REMARKS/ARGUMENTS

Application No.: 10/021,000 Reply to Office Action of September 23, 2004

AMENDMENTS TO THE DRAWINGS:

F I G . 16

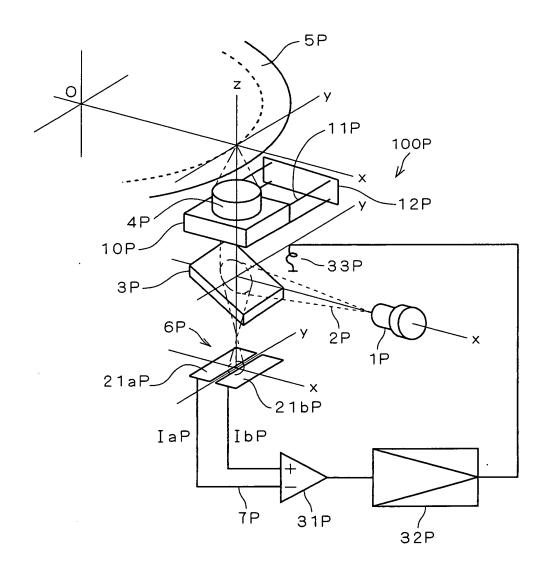
The Examiner objected to Figs. 16-18 because they need a

legend such as "Prior Art." Without conceding that the subject

matter shown in Figs. 16-18 can be properly construed as prior

art against the claimed invention, Applicant has filed a drawing

correction concurrently herewith in which the legend "Background

Art" has been added to Figs. 16-18. Thus, the Examiner is

16-18. In Fig. 16-18, the legend "BACKGROUND ART" has been

added.
